**From:** Mary Jo Brenden [mjbrenden@piic.org]  
**Sent:** Friday, February 17, 2012 11:50 AM  
**To:** WCO outreach Resource  
**Cc:** Phil Mahowald  
**Subject:** Prairie Island Indian Community Comments  
**Attachments:** Christine Pineda letter 2.17.12.pdf

Attached please find the Comments of the Prairie Island Indian Community on the draft report "Background and Preliminary Assumptions for an Environmental Impact Statement—Long-Term Waste Confidence Update."

PIIC Comments on Long Term Waste Confidence Update

Figure 1

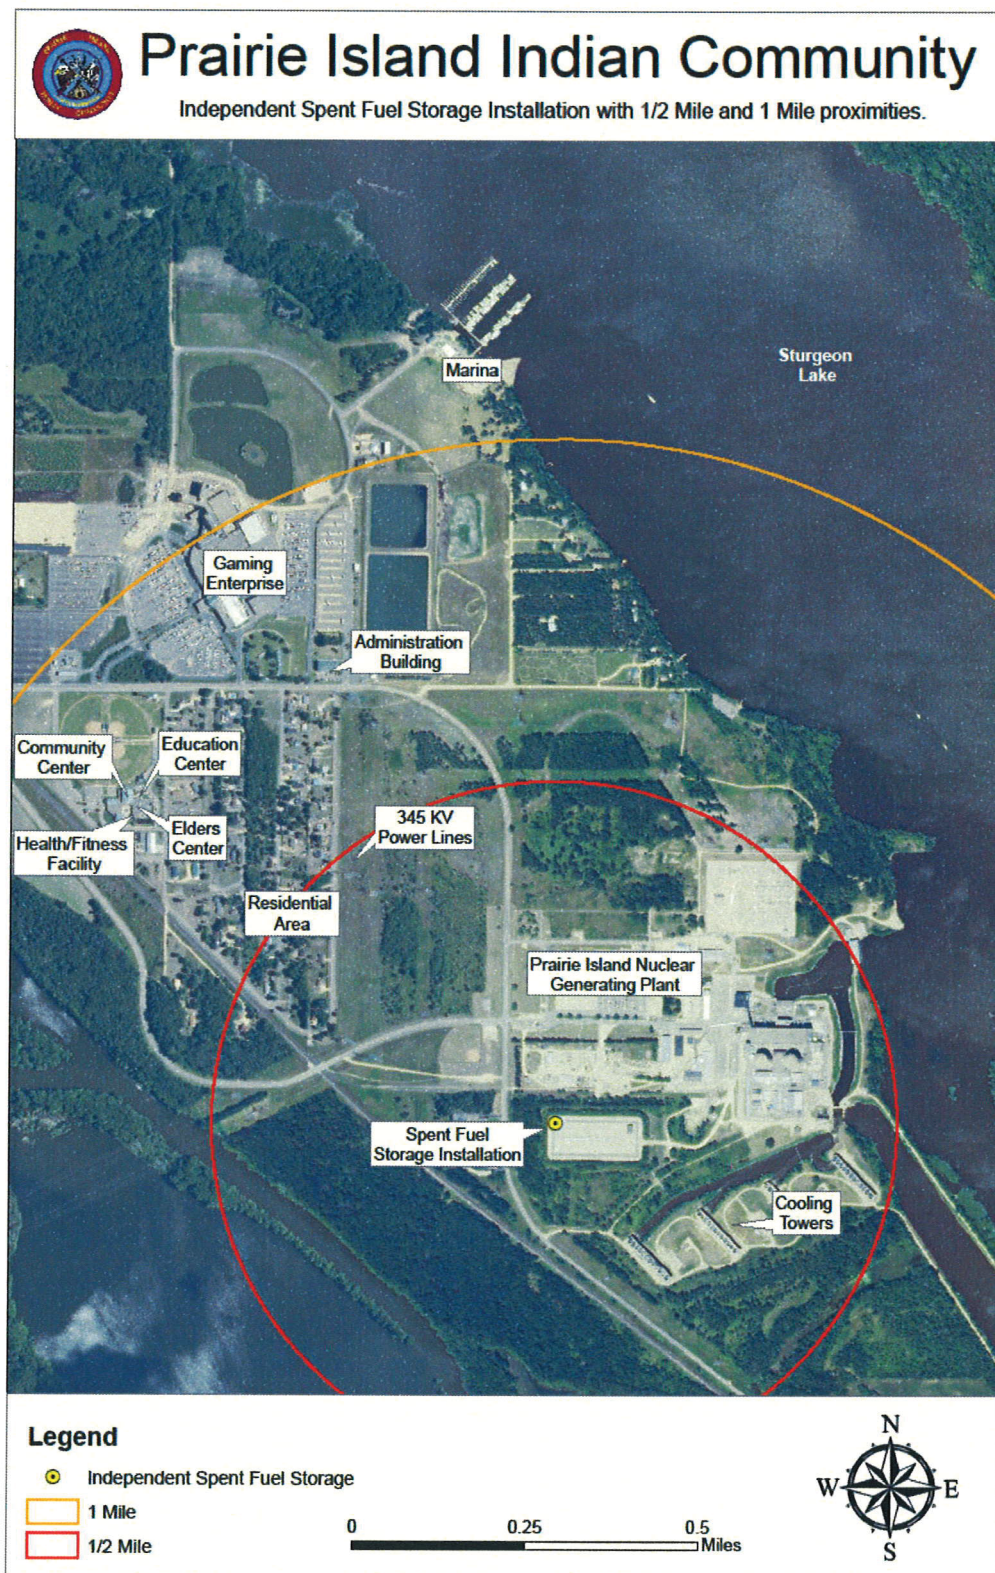
The Prairie Island Nuclear Generating Plant (PINGP), owned by Northern States Power Company d/b/a Xcel Energy (Xcel), is located on our Tribe's ancestral homeland and immediately adjacent to the PIIC reservation. See Figure 1. The PINGP has been online since the early 1970s and will operate at least until 2034 (both operating licenses were renewed in June 2011 for an additional 20 years). Like many utilities, Xcel also operates a site-specific Independent Spent Fuel Storage Installation (ISFSI), which is licensed by the NRC. The ISFSI is approximately 600 yards from the nearest Community residences, and is located on the west bank of the Mississippi River in an area that is quite popular for recreational boating and heavily used by barges. If the PINGP is decommissioned in 2034, the spent fuel is estimated to require a total of 98 casks – approximately 2500 tons of spent nuclear fuel. Most recently, Xcel has applied for a 40-year license extension for the ISFSI because its initial 20-year license is set to expire in 2013. In addition, Xcel will have to apply for a license amendment for the ISFSI to increase its storage capacity to 98 casks, to provide enough on-site storage during the period of extended operation and for decommissioning.

As the NRC is well aware, these ISFSIs are not located in remote parts of the country. Many are located near population centers. In our case, the ISFSI is located right next to us, 600 yards away from our homes, community center and business, as seen in Figure 1. As we mentioned earlier, Prairie Island is our *only* homeland, the land promised to us by the United States government. We cannot simply relocate to another place away from a nuclear waste dump. The process to acquire additional lands, apply to transfer them into trust, and have them placed into trust and designated at PIIC's reservation is a long, complex, and expensive endeavor, and there are no guarantees that the fee-to-trust application would be approved.
